70 Ember Farm Way East Molesey Surrey, KT8 OBL 6th July 2023

I am submitting an objection to the application 2022/3525 (Molesey Venture Site, Orchard Lane, East Molesey) on the grounds that the Flood Risk Assessment provided to support the application completed by KRS Environmental and the commissioned by Lifestyle Residences and Sons of the Divine Providence does not adequately assess the flood risk of the development. There are 4 areas of concern:

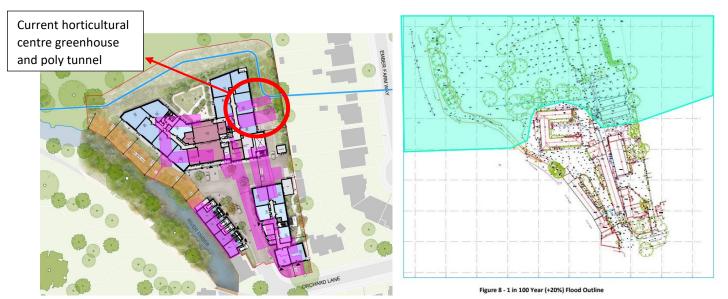
I would therefore assume that a sequential test has not been done for this site. As a result the application is contrary to the NPPF and Elmbridge LPA Flood Risk Management policies.
